Item ID: D209-669-013 Accept *N900040100* Setup Start *NS1*
Revision ID: Stop *NS2*
Item Name: AH-1F/P/S Skidtube LH with Standard Wearplates
Start Date: 12/19/2016 Start Qty: 1.00 *1* Cust Item ID:
Required Date: 1/5/2017 Req'd Qty: 1.00 *1* Customer:
Reference:

DART SERVICE INSTRUCTION

TO AMEND INSTALLATION INSTRUCTIONS IIN-D209-669 REV. B

A	NEW ISSUE	AJS	09.02.24
REV.	DESCRIPTION	BY	DATE
DESIGN	AJS	DART AEROSPACE LTD HAWKESBURY, ONTARIO, CANADA	
DRAWN	AJS		
CHECKED		DRAWING NO.	REV. A
MFG. APPR.	N/A	DSI 9450	SHEET 1 OF 3
APPROVED		TITLE	SCALE
DE APPR.		SKIDTUBE INSTALLATIONS	NTS
DATE	09.02.24	COPYRIGHT © 2009 BY DART AEROSPACE LTD THIS DOCUMENT IS PRIVATE AND CONFIDENTIAL AND IS SUPPLIED ON THE EXPRESS CONDITION THAT IT IS NOT TO BE USED FOR ANY PURPOSE OR COPIED OR COMMUNICATED TO ANY OTHER PERSON WITHOUT WRITTEN PERMISSION FROM DART AEROSPACE LTD.

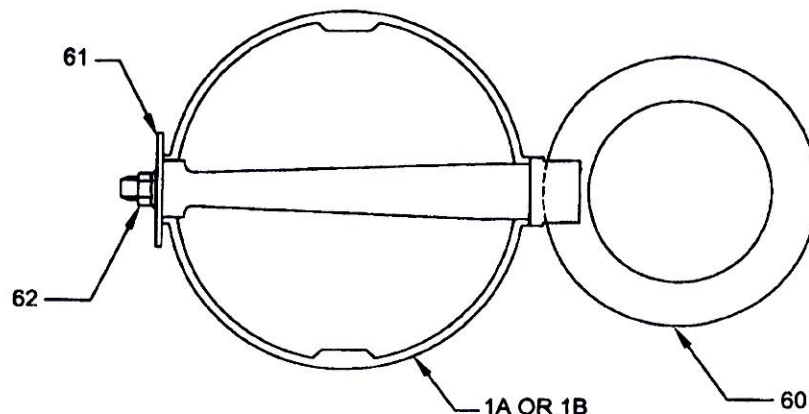
- 1) FOR D209-669-011/-012/-013/-014 SKID TUBES @ CHANGE 003 AND SUBSEQUENT, MODIFY THE FOLLOWING:
 - a) REPLACE THE D2968-041 TOW RING WITH THE D3407-041 TOW RING ASSEMBLY.
 - b) REPLACE THE D2736-1 AND D2736-3 GHW LUGS WITH THE D3405-041 AND D3405-043 LUG ASSEMBLIES.
 - c) AMEND THE PARTS LIST IN SECTION 5.0 OF INSTALLATION INSTRUCTIONS IIN-D209-669 REV. B AS SHOWN ON PAGE 2 OF THIS DSI.

INSTALL TOW RING ASSEMBLY AS SHOWN BELOW (REFER TO SECTION F-F OF IIN-D209-669 REV. B.

IS:
